Docket Number:	13-AFC-01
Project Title:	Alamitos Energy Center
TN #:	214149
Document Title:	Testimony of Bill Powers, P.E., Alamitos Energy Center Final Staff Assessment
Description:	October 21, 2016
Filer:	ELIZABETH LAMBE
Organization:	Los Cerritos Wetlands Land Trust
Submitter Role:	Intervenor
Submission Date:	10/21/2016 4:26:18 PM
Docketed Date:	10/21/2016

Testimony of Bill Powers, P.E.
Alamitos Energy Center Final Staff Assessment
Docket 13-AFC-01

Prepared for Los Cerritos Wetlands Land Trust

October 21, 2016

Figure 1. Location of La Paloma Generating Station Relative to LA Basin⁴

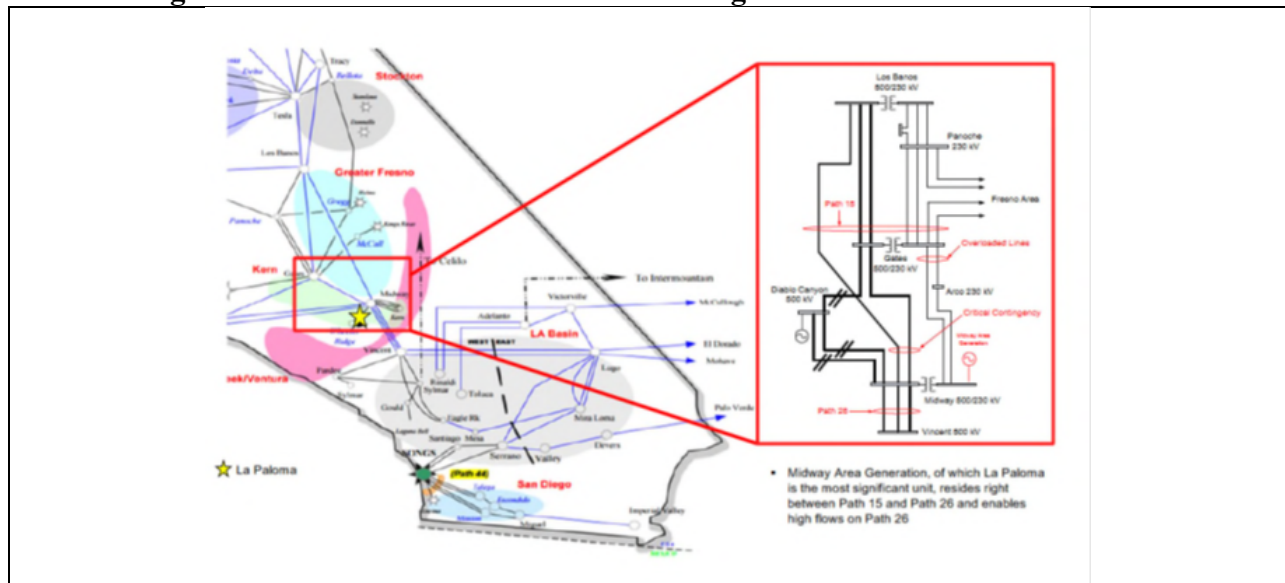
As shown in Figure 1, La Paloma sits on Path 26, the main north-south transmission trunk line into the LA Basin. The transmission lines assumed out-of-service during a 1-in-10 year peak demand reliability event are located to the southeast of the LA Basin.³ Therefore, the Path 26 transmission trunk line would be fully operational during the 1-in-10 year reliability event and power from La Paloma would be fully deliverable to the LA Basin during the event.
